Potential Interference with Cutting Unit Pitch Arms and Roll Frame

Product: Greensmaster Flex 1820/2120

February 26, 2016

Subject: Potential Interference with Cutting Unit Pitch Arms and Roll Frame.

Figure 1

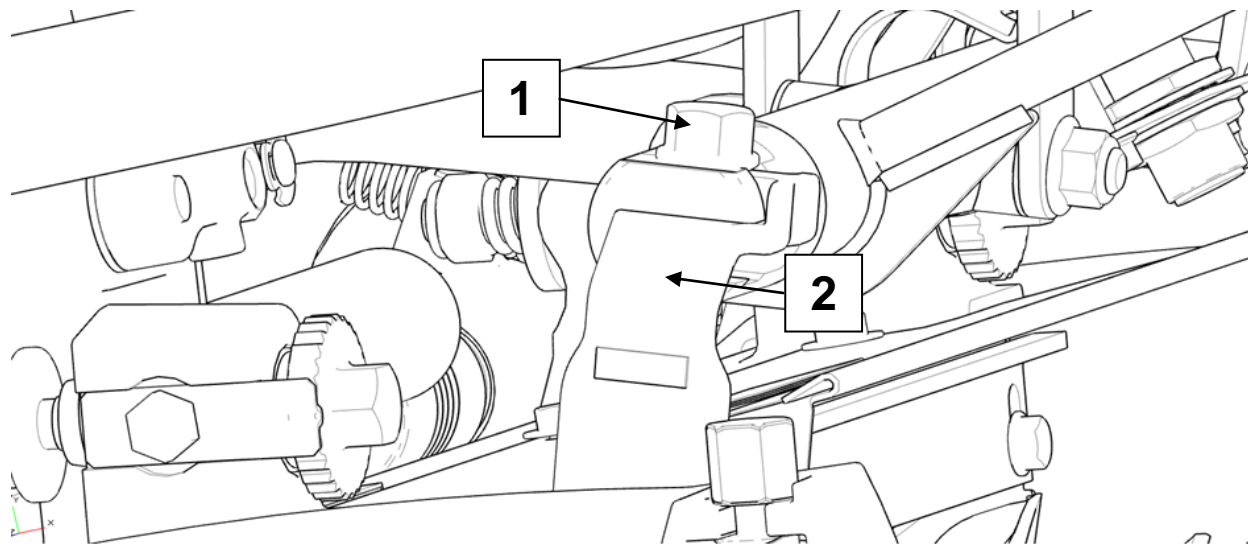
When installing 2015 or older, or some early 2016 Flex 1800/1820/2100/2120 cutting units on MY 2016 Flex 1820/2120 traction units, the roll frame bolts may interfere with the cutting unit pitch arm tabs. This interference will be apparent when securing the cutting units to the roll frame. See Figures 1 and 2 for specific information about where the potential interference points exist.

When installing specified early 2016 or 2015 and earlier Flex 1800/1820/2100/2120 cutting units on MY 2016 Flex 1820/2120 traction units, the roll frame bolts may interfere with the cutting unit pitch arm tabs. This interference will be apparent when securing the cutting units to the roll frame. See Figures 1 and 2 for specific information about where the potential interference points exist.

Mount the cutting unit and inspect for interference. If interference exists, remove cutting unit pitch arm material by grinding a 45-degree chamfer (2.28 mm/.090 inch) to both pitch arm tabs around the head of the fastener as shown in Figures 1 and 2. This will allow adequate clearance around the fastener to allow the fastener head to sit flush against the pitch arm tab and properly secure the cutting unit to the traction unit.

Mount the cutting unit and inspect for interference. If interference exists, remove cutting unit pitch arm material by grinding a 45-degree chamfer (2.28 mm/.090 inch) to both pitch arm tabs around the head of the fastener as shown in Figures 1 through 4. This will allow adequate clearance around the fastener to allow the fastener head to sit flush against the pitch arm tab and properly secure the cutting unit to the traction unit. Once modifications are complete and clearance exists between the bolt head and the pitch arm assembly, cover the chamfered area with Toro red touch up paint as required.

Figure 3

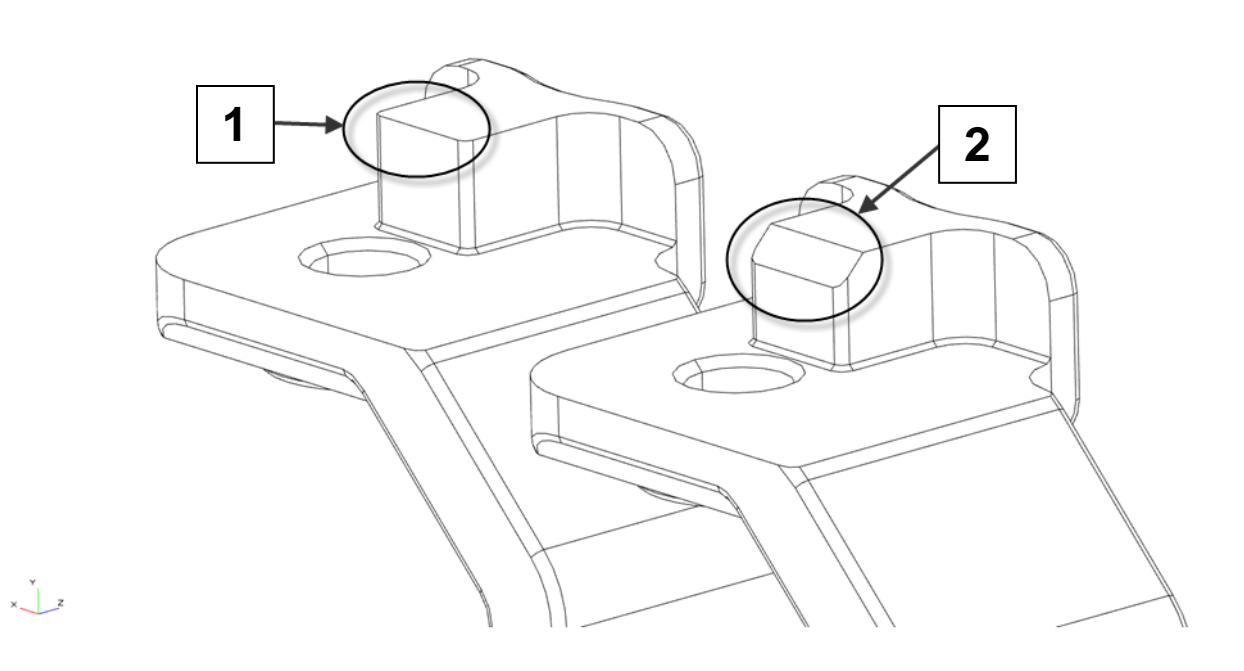
1. Early 2016, 2015 and earlier cutting unit and pitch arm assembly
2. Current 2016 cutting unit pitch arm assembly
